DART SERVICE INSTRUCTION

TO AMEND INSTALLATION INSTRUCTIONS IIN-D412-630 REV. H

REF. CANADIAN STC: SH96-69 ISSUE 5 REF. FAA STCs: SR00595NY, SR00597NY, SR00598NY

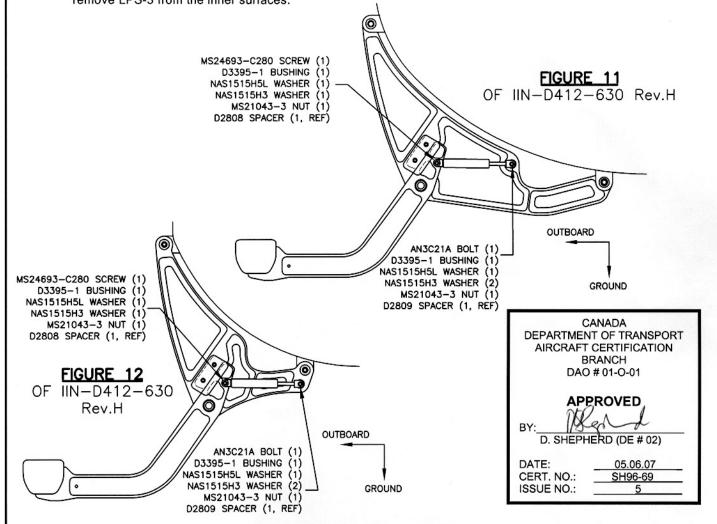
The hardware for the D412-630-023/-024 steps is changed as shown in the figures below. The correct parts list for the D412-630-023/-024 steps is given on page 2 of this document.

All exposed fasteners of the D412-630-023/-024 steps have been coated with LPS Laboratories' "LPS Procyon". In corrosive environments, it is recommended to coat all fasteners and faying surfaces with LPS Laboratories LPS-3 Corrosion Inhibitor and coat the exposed surfaces of all torqued fasteners with LPS Procyon. Excess LPS can be removed using a degreaser (MEK) as needed. Ensure that the degreaser is not overused such that it would remove LPS-3 from the inner surfaces.
